REMARKS

Claims 39 and 40 are the only claims at issue. The Examiner rejected claims 39 and 40 under 35 U.S.C. § 112 as failing to comply with the written description requirement. The basis for this rejection is found on pages 2 and 3 of the Office Action mailed 11/30/2005, where the Examiner stated that

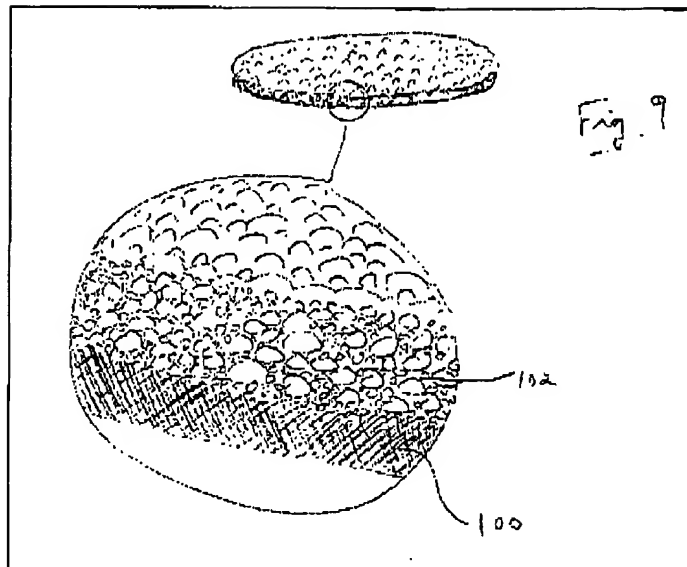
“...claim 39 contains the limitation ‘a particulate layer...is at least two particulate particles thick.’ The specification does not disclose the thickness of the particulate layer, therefore this limitation is considered new matter.” “Furthermore, the drawings do not support this limitation since figure 9 shows that the particle layer is discontinuous and sometimes not even one particle thick.”

"Figure 9 does not differentiate, e.g., point out, which parts of the drawing refer to stones or fibers. Therefore, it is impossible for the examiner to distinguish whether the drawing is showing fibers or stones in the matrix, since Applicant has not identified either in any of the drawings.... When the specification does not disclose that the drawings are to scale and is silent as to dimensions, arguments based on measurement of the drawing features are of little value. M.P.E.P. 2125."

Applicant presents below the relevant portion of the informal drawing of Fig. 9 that was submitted with the application of which the present application is a divisional. Applicant has also enclosed a replacement Fig. 9 that more accurately shows the details of the informal drawing. The informal drawing and appended replacement drawing sheet clearly show the existence of numerous particles through the thickness of the flooring unit, and the particulate layer is at least two such particles thick. There are at least two particles shown between the top of the flooring unit and the fiber layer. Thus, the claim limitation that the particulate layer is at least two particles thick is fully supported by the specification.

The informal Fig. 9 shows the flooring unit with a clear view of the side and the particles across the unit’s thickness. The specification at paragraph [0038] also describes Fig. 9 as showing “[a] finished molded unit” after “epoxy resin, is mixed with stones and the mixture is poured into the mold over the fibers.” “The top, wearing surface of the molded unit is formed by the stones coated with epoxy resin 102...”. These resin-coated stones 102 are shown from the side view of Fig. 9, and constitute the particulate of the unit, as the term “particulate” is defined in paragraph [0020]. The stones are of various sizes in Fig. 9, and the thickness of the particulate layer is at least two such stones thick. Thus, Fig. 9 and the description clearly allow persons of ordinary skill in the art to recognize that the inventor invented what is recited in claim 39.

In the drawing the change is an increased number of particles shown in the side of the flooring unit as in the informal Fig. 9.

First, Fig. 9 does differentiate which parts of the drawing refers to stones and which part refers to fibers. In the specification at page 13, lines 16-18, the fibers are given the reference numeral 100 ("fibers 100 are placed in the mold. A finished molded unit is shown in Fig. 9"). Fig. 9 shows reference numeral 100 pointing to a layer of intersecting lines, which is the appearance that woven or randomly oriented glass or other reinforcing fibers have when they are in a composite. The specification also discusses "stones coated with epoxy resin 102" at page 14, lines 1-2. Fig. 9 shows reference numeral 102 pointing to a small particle, which clearly represents a stone coated with epoxy resin that forms the matrix. Thus it is possible to distinguish the stones from the fibers, and one can see that the illustration of Fig. 9 shows the thickness of the structure being greater than two of such stones.

Furthermore, Applicant is not making an argument based on measurement of a drawing, as the Examiner pointed out and the M.P.E.P. section discusses. Instead, Applicant is making an argument based on the number of particles that the drawing discloses through the flooring unit's thickness. This specific number of clearly identified stones conveys that Applicant was in possession of the invention. Now that the standard has been met, Applicant deserves a comparison of the invention to the prior art.
